Technical Service Bulletin

CLUNK NOISE FROM REAR SUSPENSION WHEN DRIVING AT LOW SPEED AND/OR TURNING

Bulletin No.: 02-001/22

2016-2021 MX-5 with VINS lower than JM1ND*****453987 (produced before February 4, 2021)

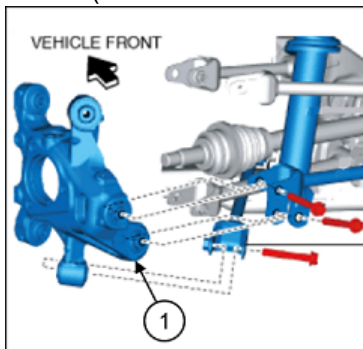
Some vehicles may exhibit a clunk noise from rear suspension when driving at low speeds and/or turning due to the rattling of the bush of the upper lateral link in the rear hub support. Dimensional variation of the bush boots in the rear hub support may cause insufficient sealing which allows water to enter the rear hub support, resulting in rust on the pillow-ball. The rust then accelerates the pillow-ball wear and causes a gap between the body and the bearing, resulting in the clunk noise during driving. To eliminate this concern, the boots in the rear hub support have been modified to improve sealing.

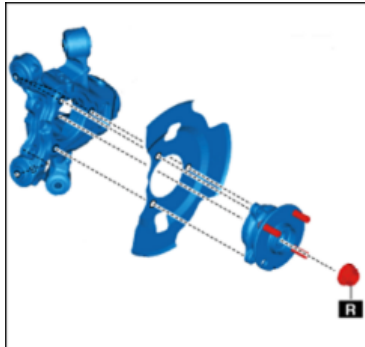
1. Verify the customer concern.
2. Replace the hub support (1) only on the side where the part is causing the noise according to the instructions on MGSS (WHEEL HUB COMPONENT REMOVAL/INSTALLATION).
